**Proposed Changes to:
Mitigation Suitability of the Suncadia
(Lamb and Anderson) Trust Water Rights**

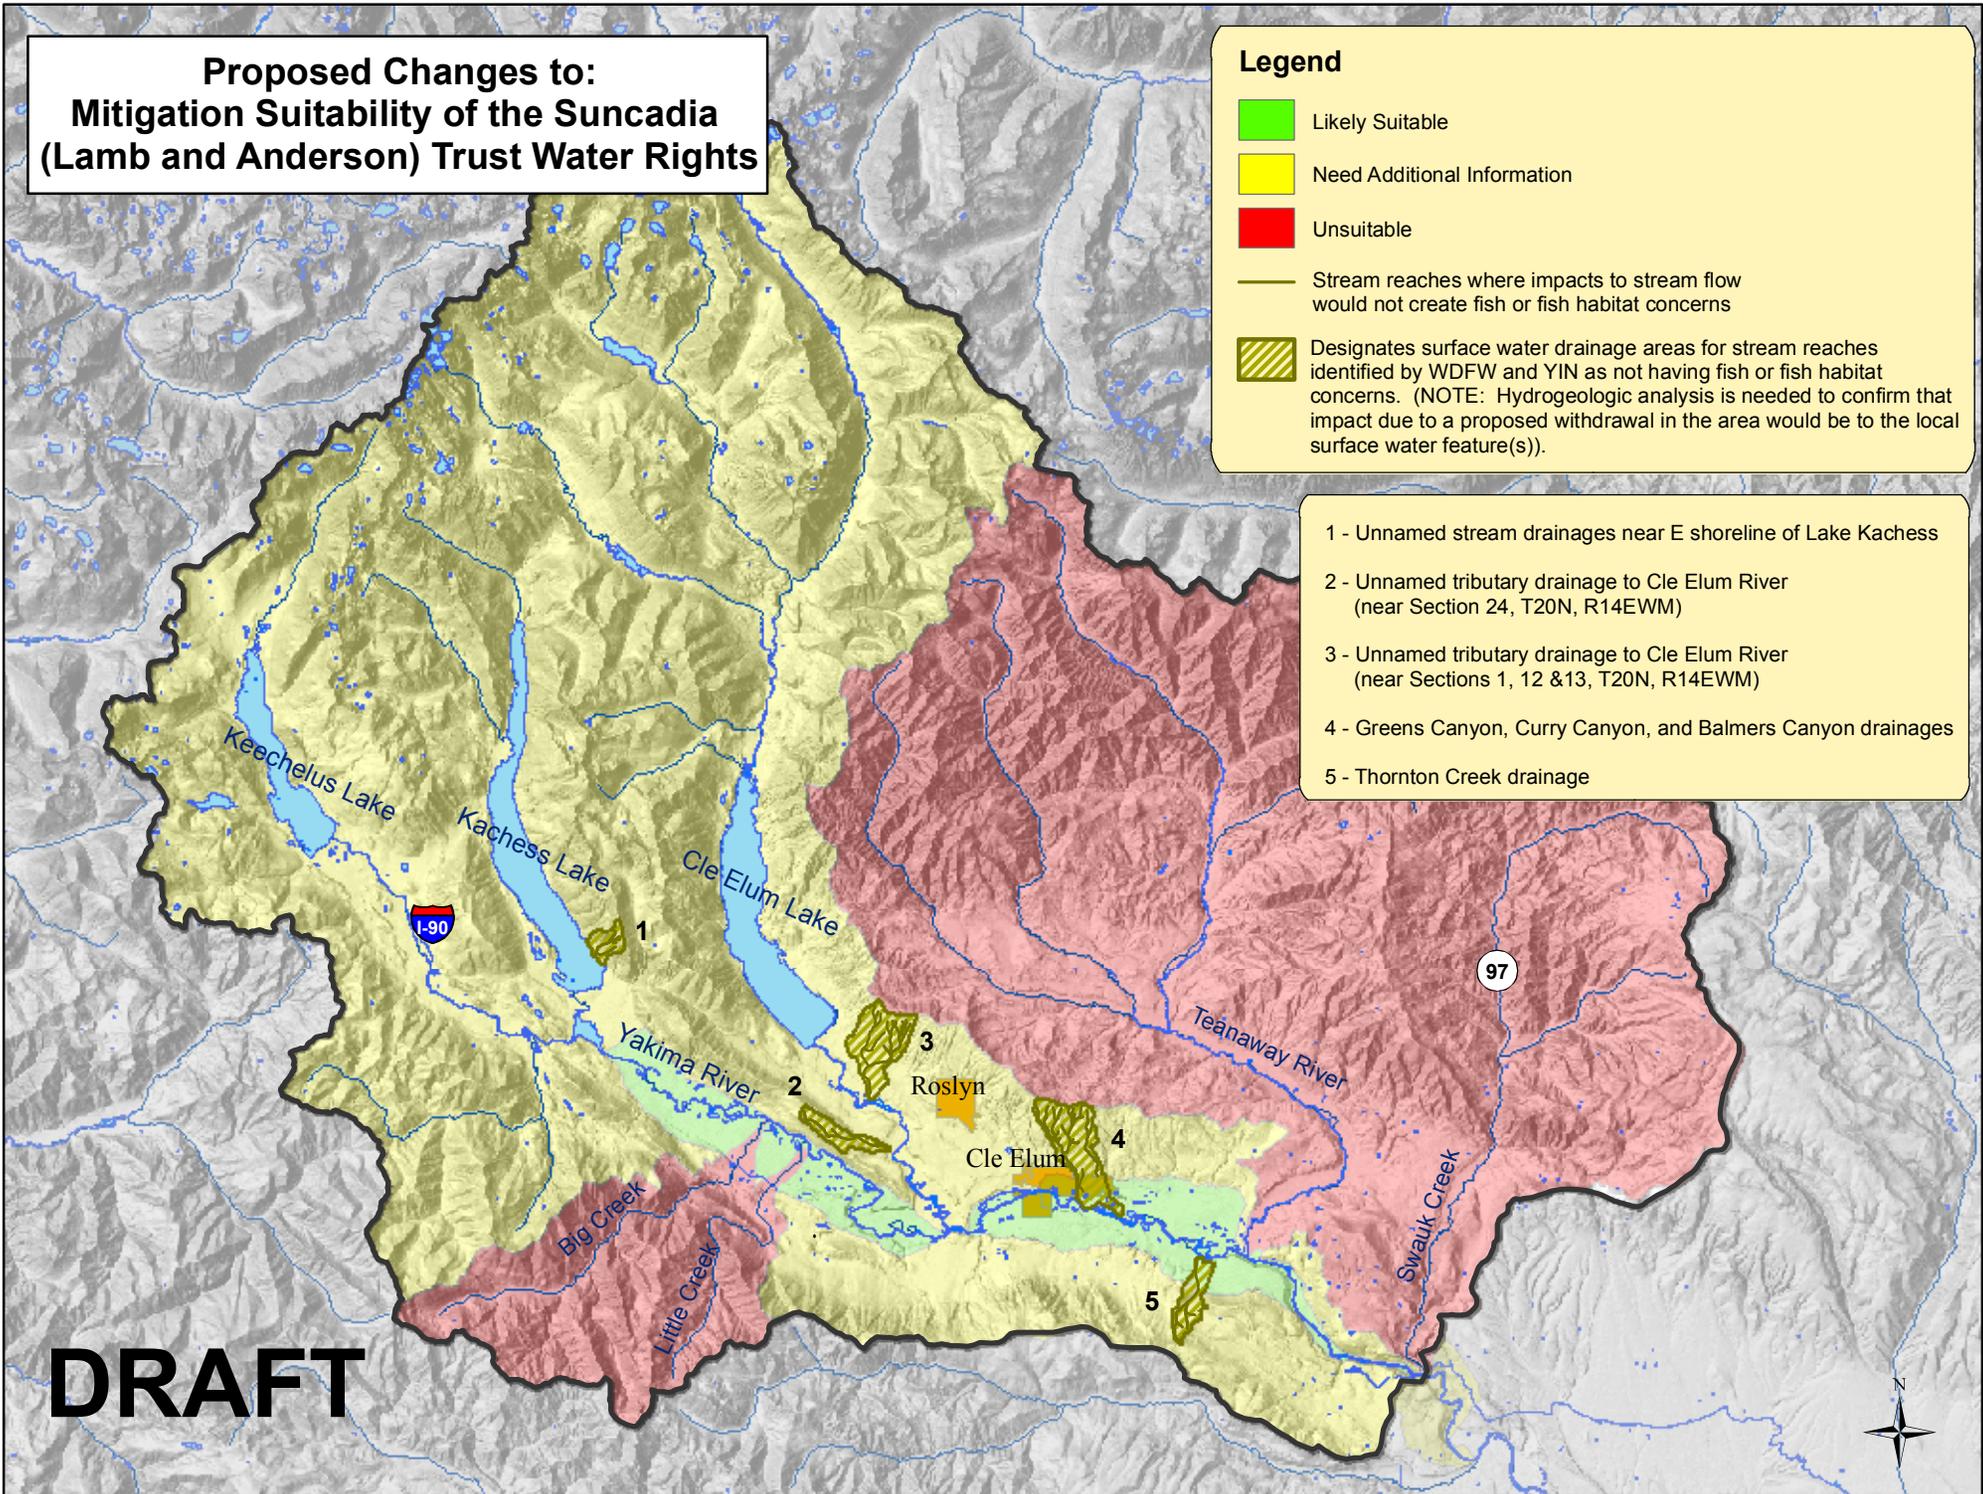
- 1 - Unnamed stream drainages near E shoreline of Lake Kachess
- 2 - Unnamed tributary drainage to Cle Elum River (near Section 24, T20N, R14EWM)
- 3 - Unnamed tributary drainage to Cle Elum River (near Sections 1, 12 & 13, T20N, R14EWM)
- 4 - Greens Canyon, Curry Canyon, and Balmers Canyon drainages
- 5 - Thornton Creek drainage
